2014FA12
May, 2015
Page 1 of 5

SUBJECT: H 50 EP System™ Software Release to Improve Drive Unit Life in Transit Application

MODELS AFFECTED: H 50 EP System™ Transit Buses Equipped with Cummins ISB or ISL Engines MY 2007 or Newer

Figure 2. Adjustable Low Idle Speed Configuration

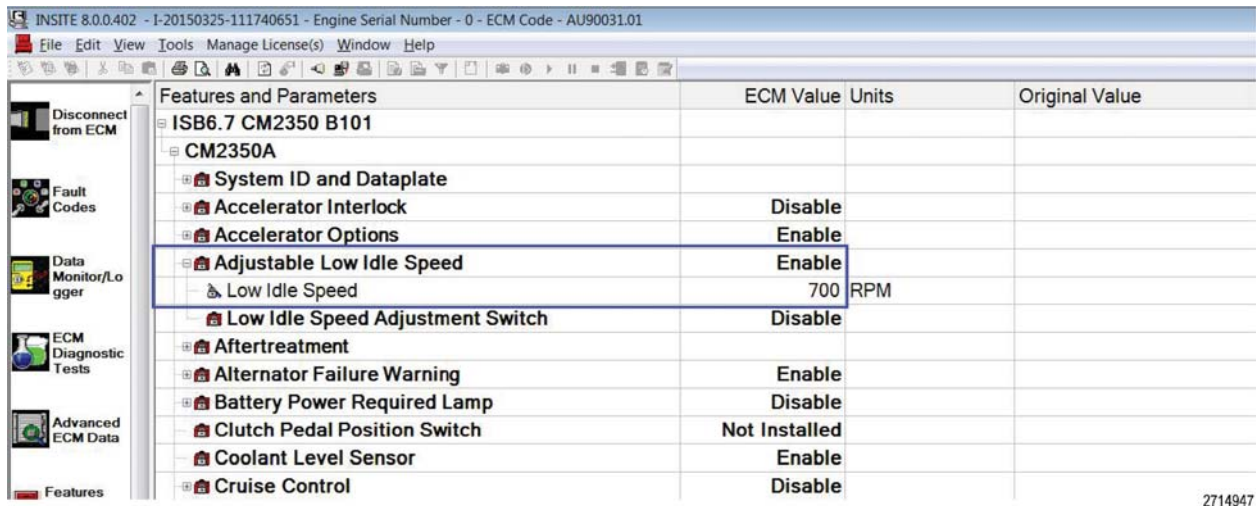
- Adjustable Low Idle Speed – Refer to [Figure 2](#)
 - Adjustable Low Idle Speed must be “**Enabled**”

- 3rd Generation Control Systems – Low Idle Speed MUST be set at “**700 RPM**”
- 4th Generation Control Systems – Low Idle Speed to be INITIALLY set at “**700 RPM**”.

NOTE: 4th Generation Control Systems – If DTC 65-18 becomes active during the road test, reset the Low Idle Speed at 750 rpm. Some OEMs specify that the Low Idle Speed be set at 750 rpm. DTC 65-18 will set if an excessive mismatch exists between the actual engine rpm and the rpm specified in the calibration.

NOTE: Figure 2 shows the Low Idle Speed to be set at 700 rpm. The Low Idle Speed may be set at 700 rpm or 750 rpm for 4th Generation control systems depending on OEM Customer Specification Sheets (CSS) request.
